MISSISSIPPI POWER & LIGHT COMPANY

SUBJECT: Grand Gulf Nuclear Station  
Units 1 and 2  
Docket Nos. 50-416 and 50-417  
File 0260/0862/L-340.0/L-334.0  
Transmittal of Proposed FSAR  
Changes and Responses to  
NRC Formal and Informal  
Questions  
AECM-81/345

- Attachments:
1. Question and Response 260.1
  2. Revised Question and Response 362.7
  3. HGEB SER Open Item - Ultimate Heat Sink
  4. NRC Concern - Shared Systems
  5. SER Open Item - Soil-Structure Interaction

SETTLEMENT VS TIME  
UNITS 1 & 2  
STANDBY SERVICE WATER  
COOLING TOWER BASINS  
FIGURE 2.5-75h SHEET 1 OF 2

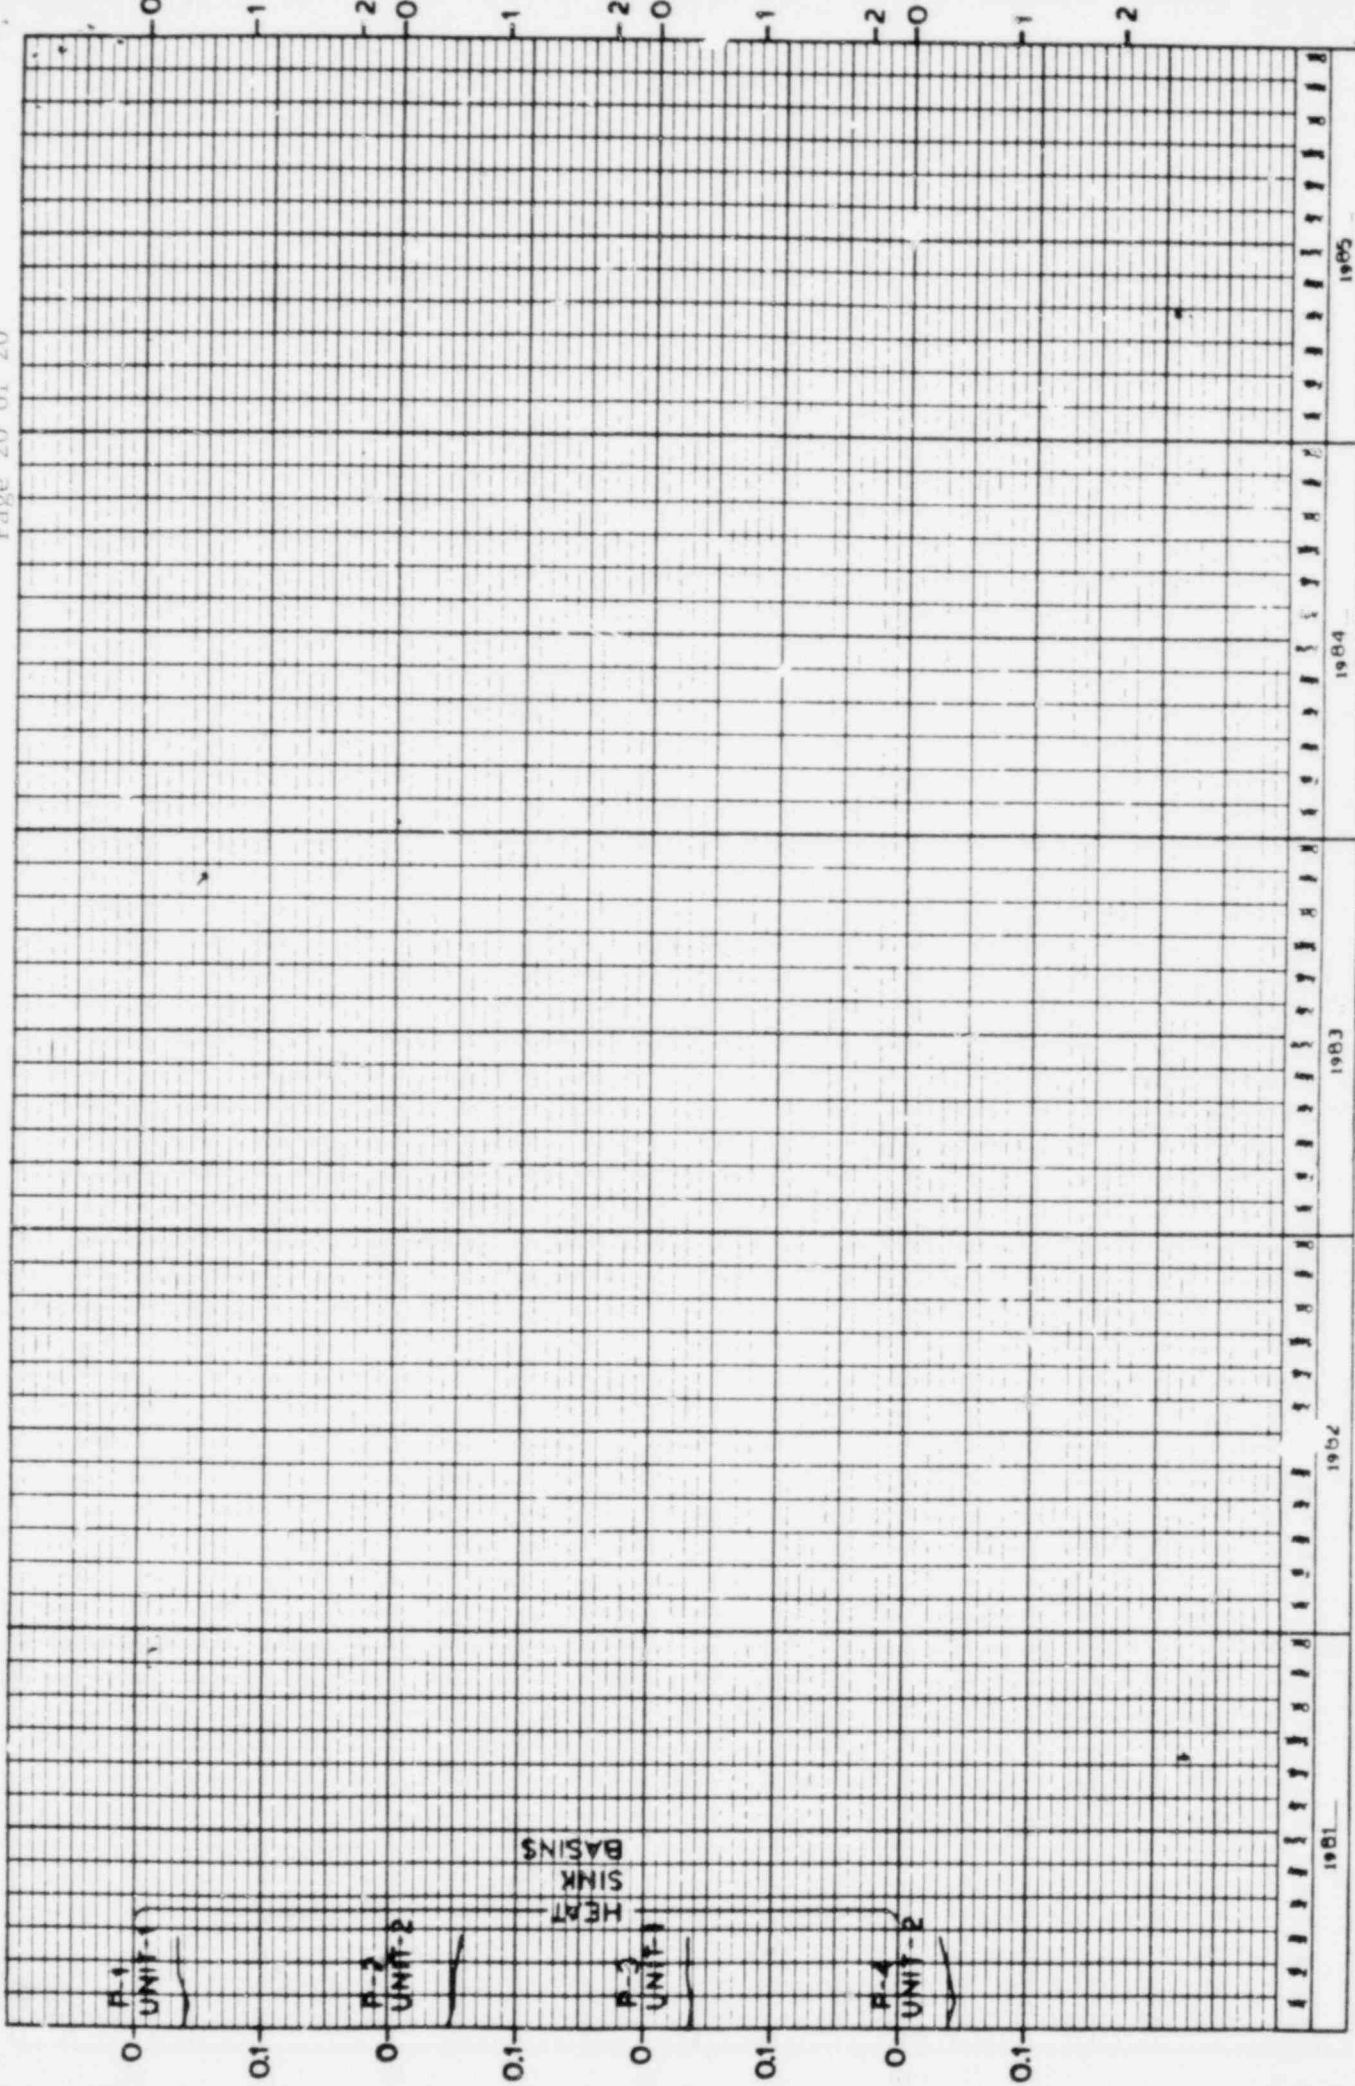
362.7 Your response to NRC Question 362.5 (page Q&R 2.5-14, Amendment 30) is not complete. Indicate what measured value of differential settlement would cause code allowable stresses to be exceeded for individual buildings and buried piping and require notification of NRC. Provide a table of these values and the limiting stress criteria. Update the plots which show settlement recorded to date versus time; this is particularly important since construction of Unit 2 was still underway when your response to Question 362.5 was being developed.

The response to this question is given in revised subsection 2.5.4.13.1, revised Table 2.5-10, and revised Figures 2.5-75a through 2.5-75h.

The settlement markers will be read at one-month intervals until construction is complete and all pools are filled with water, at which time the results of the settlement monitoring program will be evaluated and long-term monitoring of the structures will be assessed. Total settlement will not be a Geotechnical concern until the following measured values are observed:

Turbine building	3"
Radwaste building	3"
Control building	3"
Containment building	3.5"
Auxiliary building	3.5"
Diesel generator building	3"

FIGURE 2

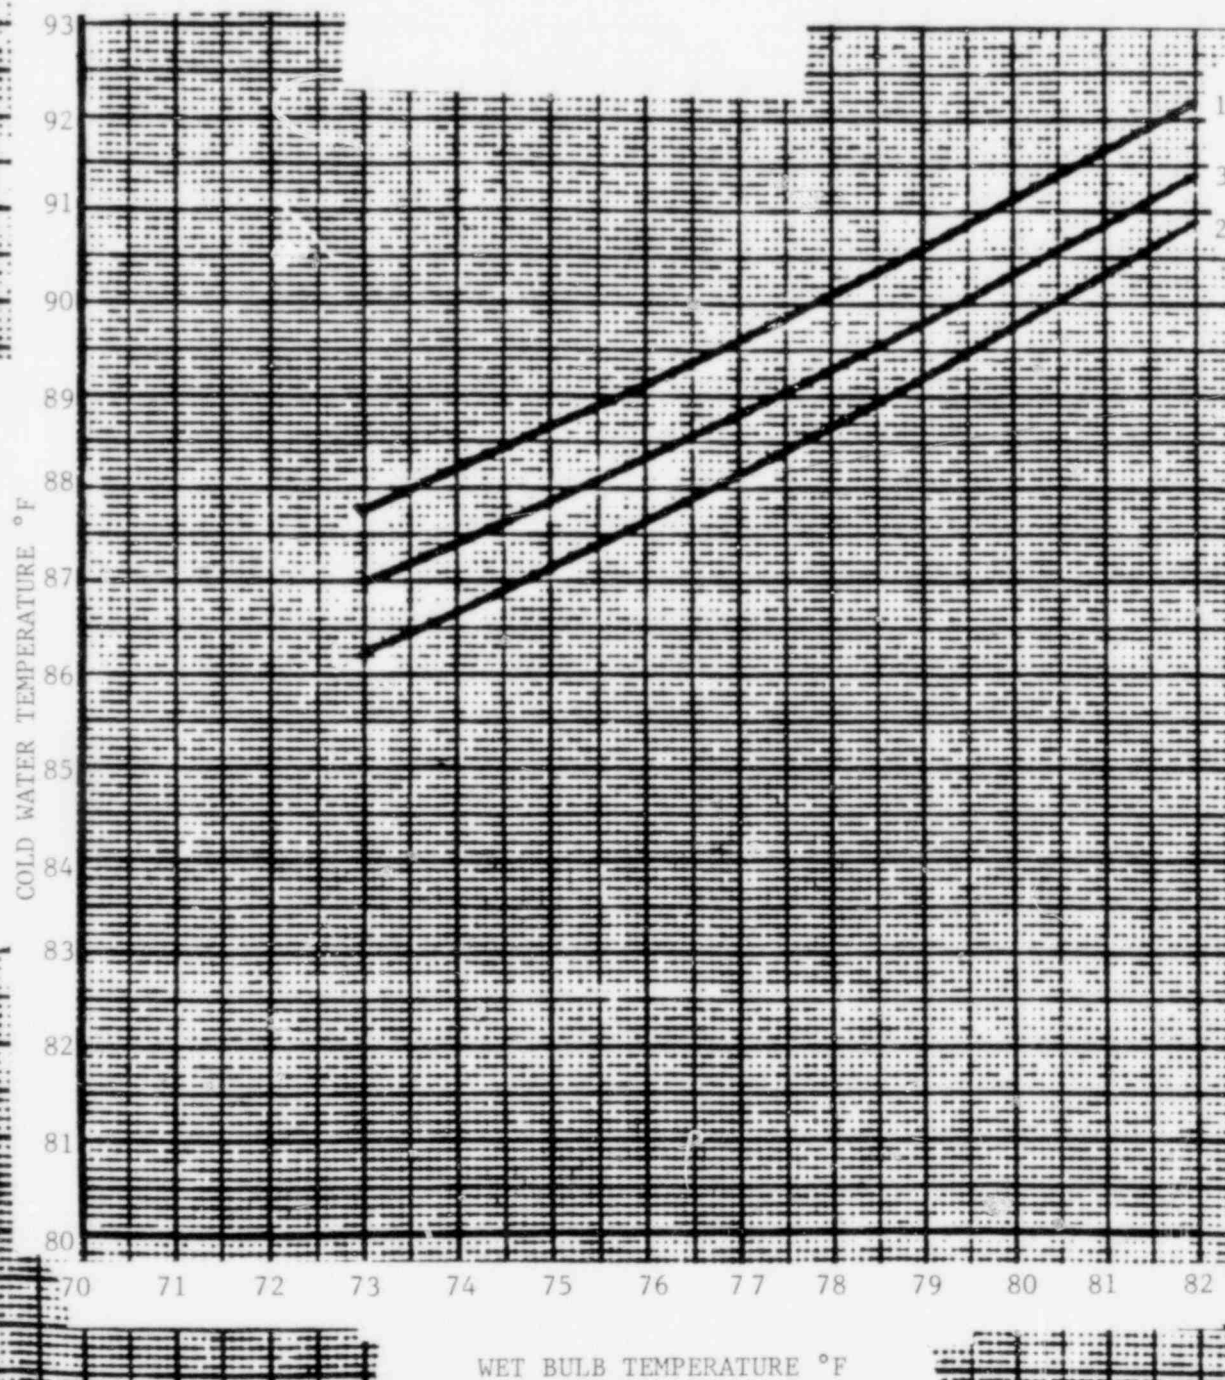
6. Provide a summary of results and assumptions on vendor tests of the mechanical draft cooling towers on the UHS.

The Ceramic Cooling Tower Company Engineering Report (Figure 1) shows performance curves (Figure 2) for 3 different conditions. Case 1 is closest to our conditions. The actual conditions that we could expect are 11,385 gpm and 130.9°F hot water temperature.
